INNER WEST COUNCIL

DEVELOPMENT ASSESSMENT REPORT

Application No.	DA201600674.01
Address	56 Ewart Street, Marrickville
Proposal	To modify Determination No.201600674, dated 12 April 2017, to increase the extent of the basement to facilitate services and a rainwater tank, delete a visitor parking space, increase the amount of bicycle parking, amend the driveway ramp to accommodate an easement, provide a new pedestrian access to/from the basement, to carry out a number of internal changes, revise window configurations, provide fire booster assembly and increase the height of the building to accommodate mandatory sprinkler requirements
Date of Lodgement	10 October 2019
Applicant	02 Architecture
Owner	W Woo
Number of Submissions	Petition containing 8 signatures
Value of works	\$1,856,440.00
Reason for determination at Planning Panel	Modification seeks further variation to the FSR development standard
Main Issues	Car Parking
Recommendation	Approval subject to conditions

DRAWING TITLE
LEVEL 1 FLOOR PLAN
 DATE: NOVEMBER 2019 SCALE: 1:100 @ A3
 JOB NO: 1628
 DRAWN: DA05
 REV: 5
 PROJECT: PROPOSED RESIDENTIAL DEVELOPMENT
 56 EWART STREET, MARRICKVILLE
 WILLIS WOO

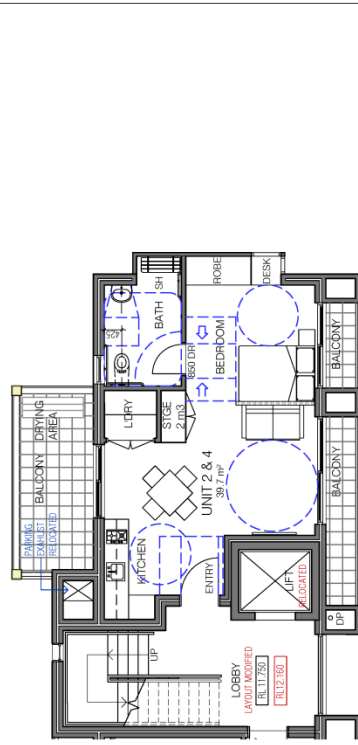
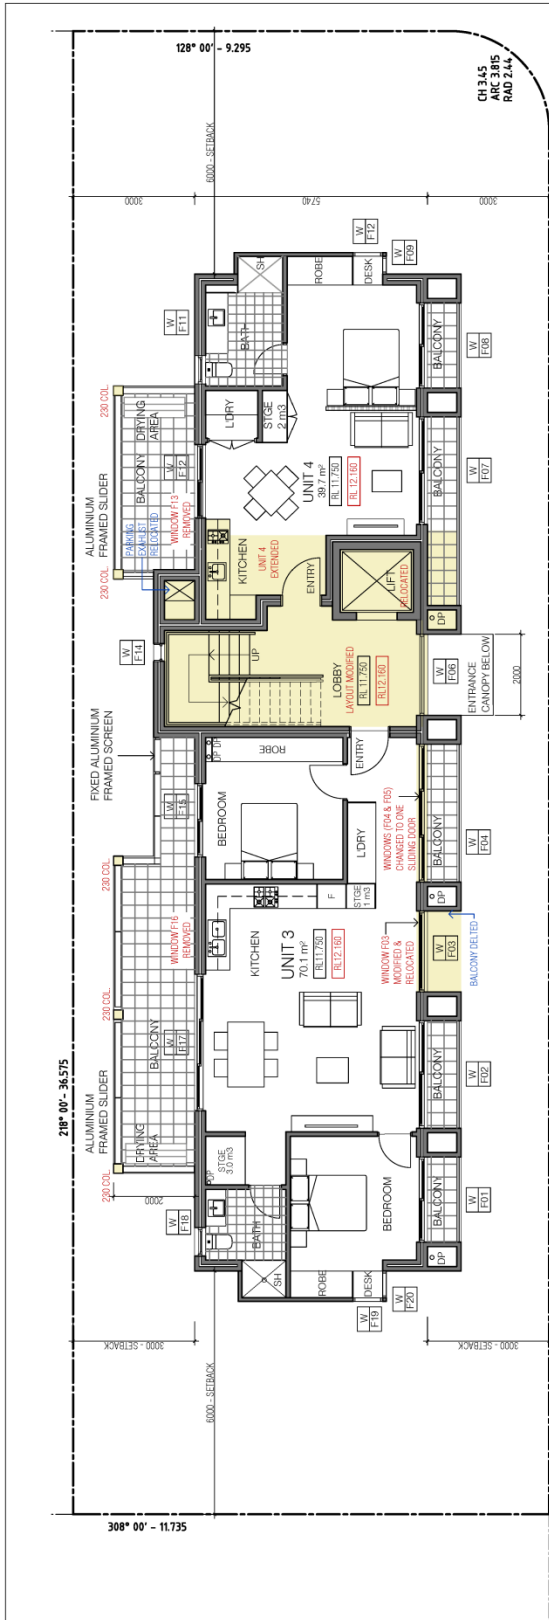
- It was considered in the assessment of the original proposal that visual privacy from the first and second floor balconies for Units 3 and 5 was acceptable. The western aspect of those balconies is screened with sliding privacy screens however the southern aspect is informally screened by clothes drying areas. The installation of clothes drying racks will provide some privacy treatment to restrict views to the dwelling at No. 2 Dibble Avenue. Given that no direct views from the principal living areas of Units 3 and 5 will be possible, no concern is raised with regard to visual privacy.

Amended plans were submitted to Council on 6 December 2019 indicating improvements to the landscaping along Dibble Avenue, deletion of the balconies to Units 3 and 5, aluminium

DRAWING TITLE
 NORTH-WEST ELEVATION

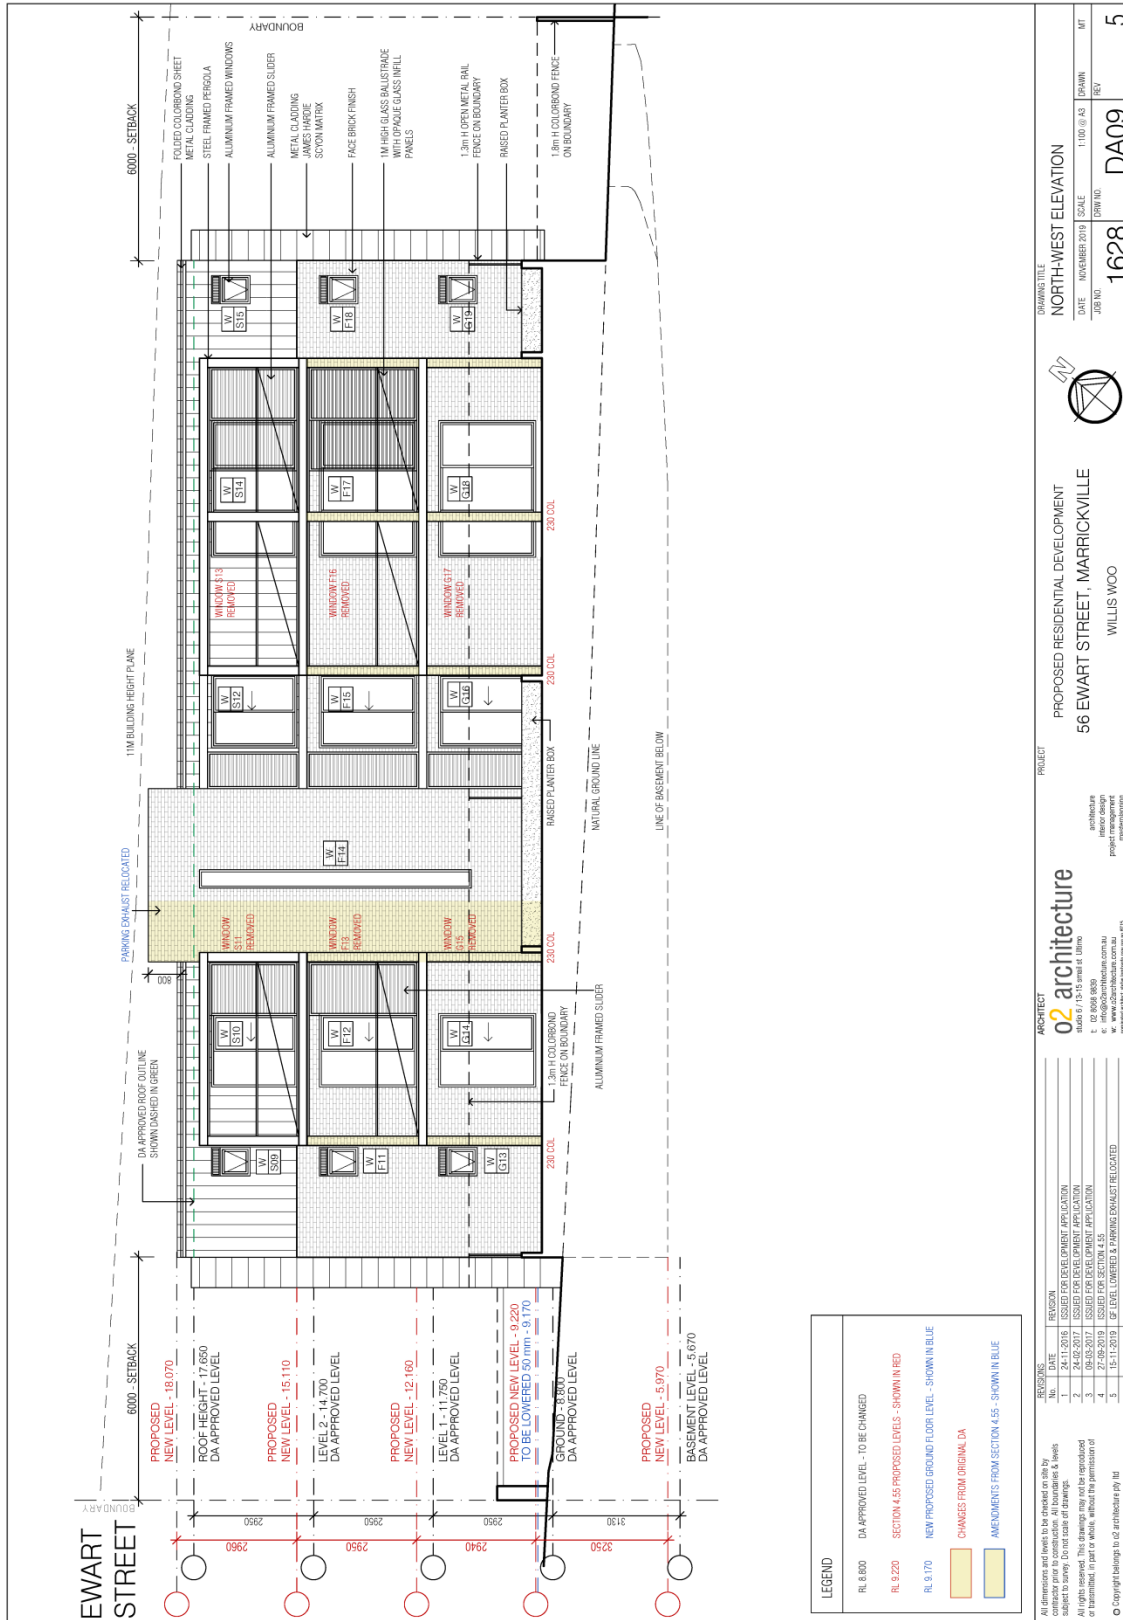
It is considered that the changes to the approved materials and finishes do not impact negatively on the overall aesthetic of the building and its compatibility with the wider streetscape. The Dibble Avenue elevation retains the originally approved 2 storey masonry form with metal mansard style upper level. The development maintains the 3 distinct masonry elements and divides the façade into appropriate sized bays to reflect the pattern of development found in the street. The overall form of the building including footprint and setbacks does not change as part of this proposal, with only a minor increase in overall height.
